Joseph M. Farley Nuclear Plant Units 1 and 2
Submittal of License Amendment Request (LAR) to
Update the Spent Fuel Pool Criticality Safety Analysis and Revise
Technical Specification (TS) 3.7.15 "Spent Fuel Assembly Storage" and TS 4.3 "Fuel Storage"

ENCLOSURE

Description and Assessment of the Proposed Changes

Figure 3.7.15-1 Fuel Assembly Burnup Limit Requirements For All Cell Storage

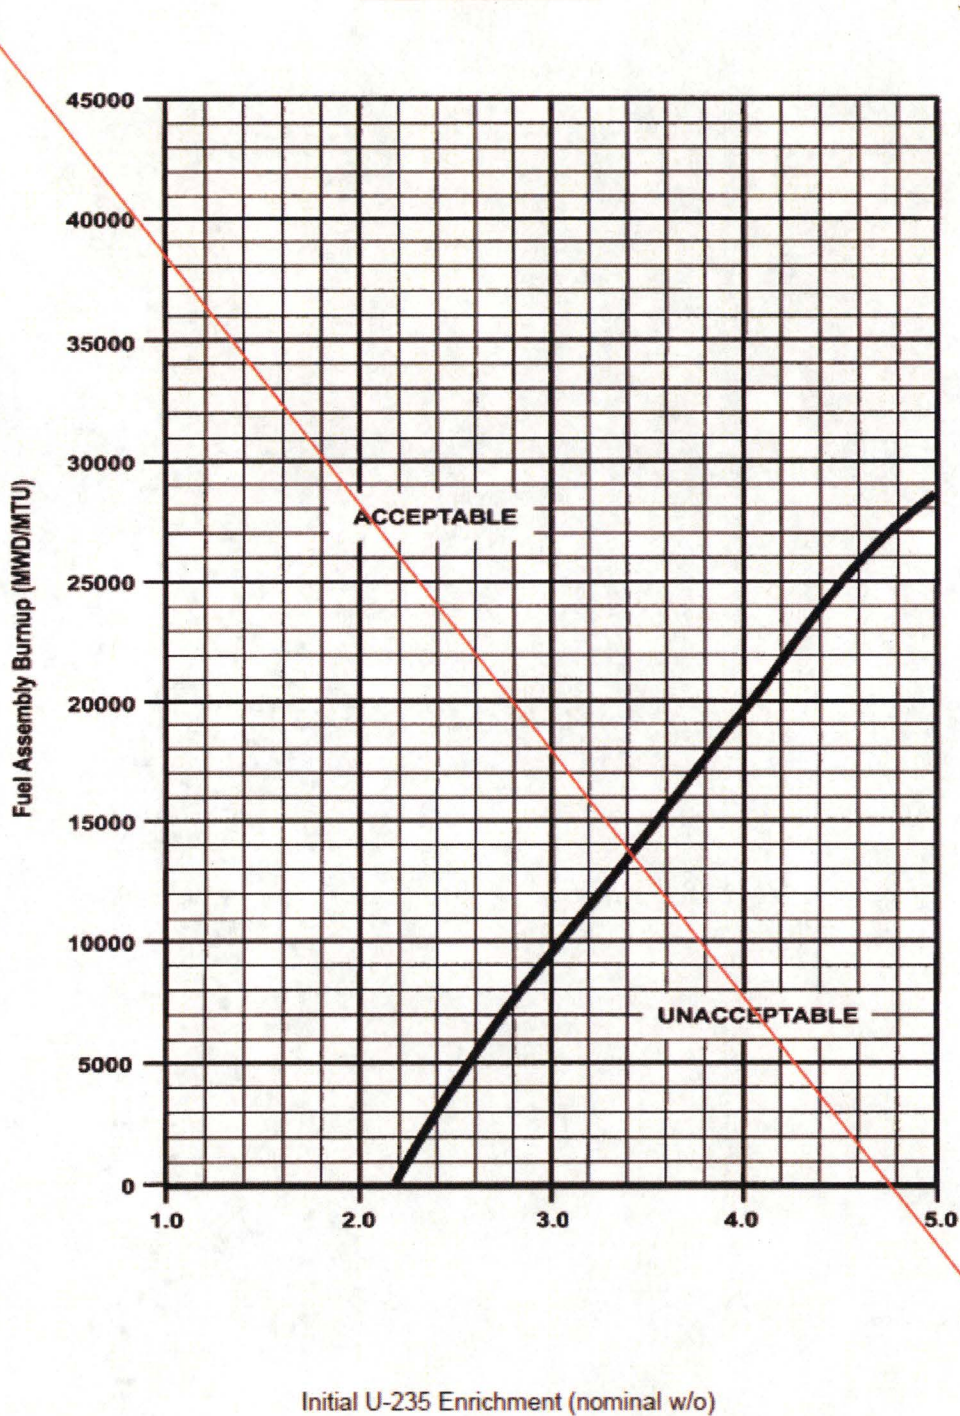
- removal of the reference to "within the Acceptable Burnup Domain of Figure 3.7.15-1",
- removal of the reference to "Figure 3.7.15-1 or" in Surveillance Requirement (SR) 3.7.15.1, and
- removal of TS Figure 3.7.15-1 which contains the fuel assembly burnup limit requirements for all cell storage. This figure will be replaced by Figure 4.3-1, Table 4.3-1, and Tables 4.3-3 through 4.3-5 in Section 4.3.

Delete Figure 3.7.15-1.

Figure 4.3-1
Fuel Assembly Burnup Limit Requirements for Low Enrichment (L)
Assembly of the Burned/Fresh Checkerboard Storage (see Figure 4.3-2)

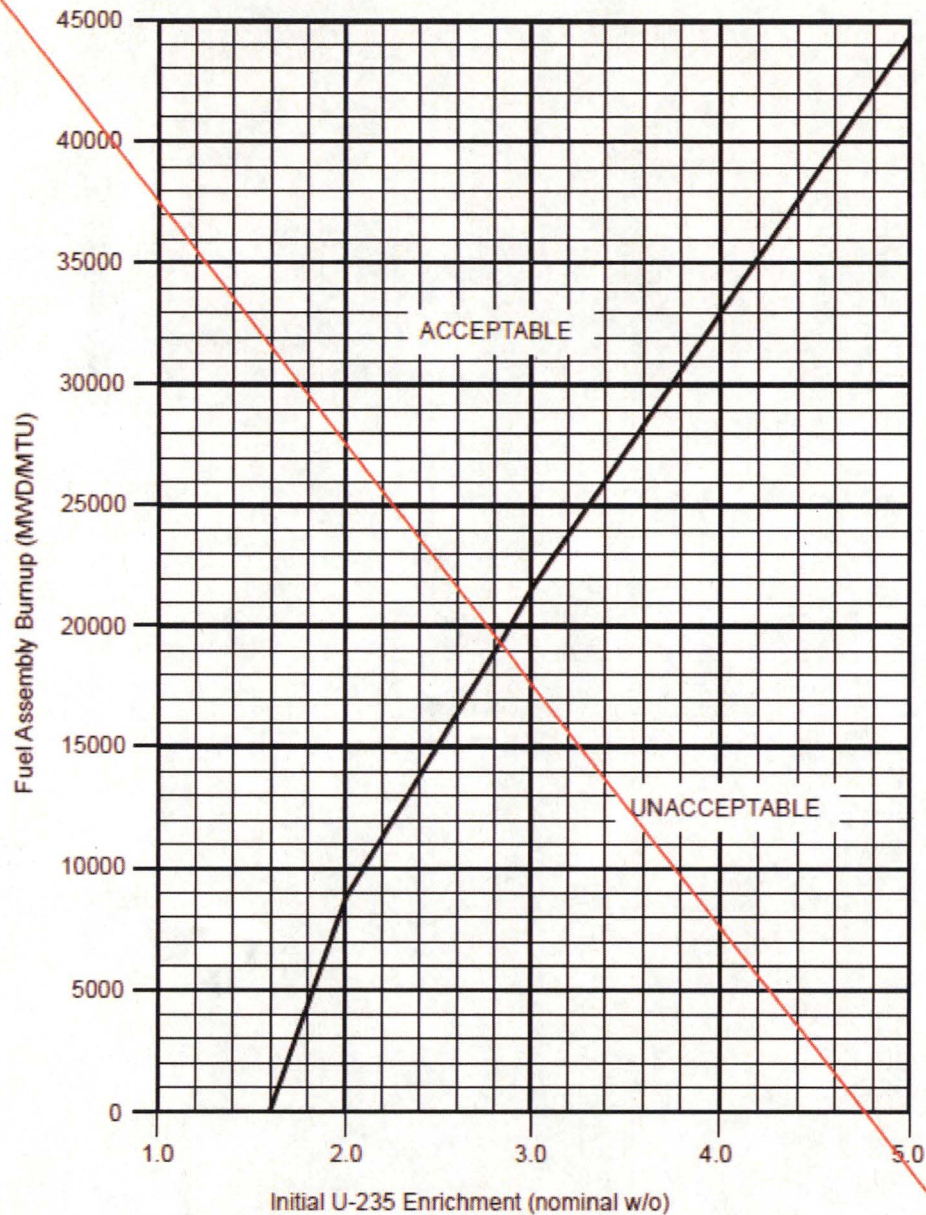
- Replacement of “Figure 4.3-6” with “Figure 4.3-2” in Specification 4.3.1.1.g.
- Replacement of Figures 4.3-1 through 4.3-5 with proposed Figure 4.3-1 and Tables 4.3-1 through 4.3-5.

Delete Figure 4.3-1 and insert revised Figure 4.3-1 and
Tables 4.3-1 through 4.3-5 (Insert 1).

- The proposed Figure 4.3-1 contains graphical and verbal descriptions of the four allowed storage arrays.
 - The proposed Table 4.3-1 provides interpretation of the fuel categories included in Figure 4.3-1 and it includes references to the appropriate table that provides the fitting coefficients that are to be used to calculate the minimum required fuel assembly burnup or the minimum IFBA requirement.

Figure 4.3-2
Spent Fuel Storage Configurations

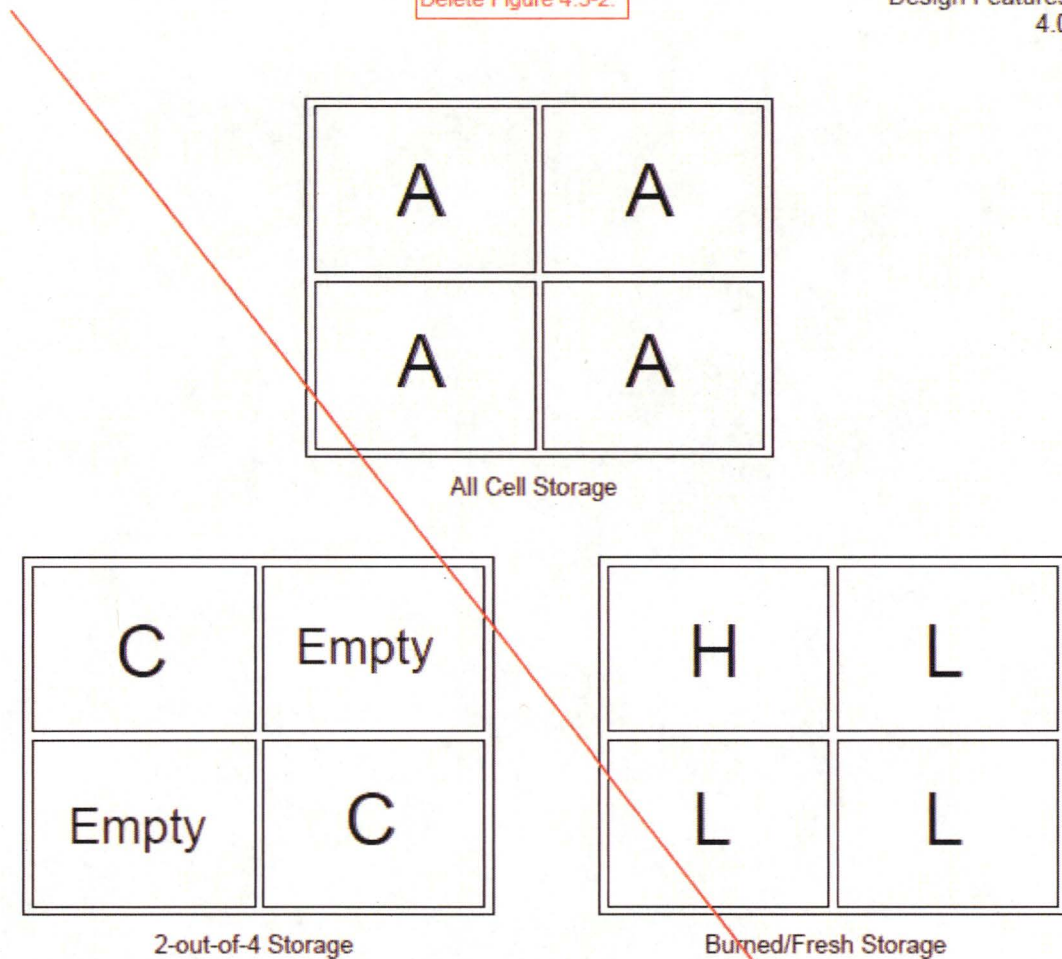
Delete Figure 4.3-2.

Figure 4.3-3
Interface Requirements

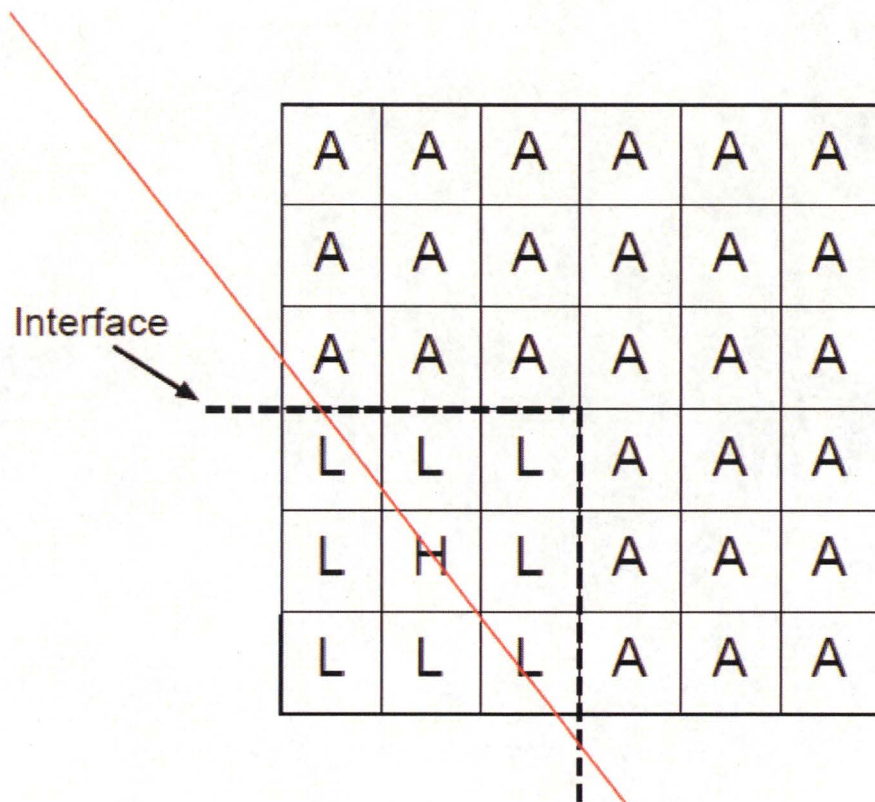
Delete Figure 4.3-3.
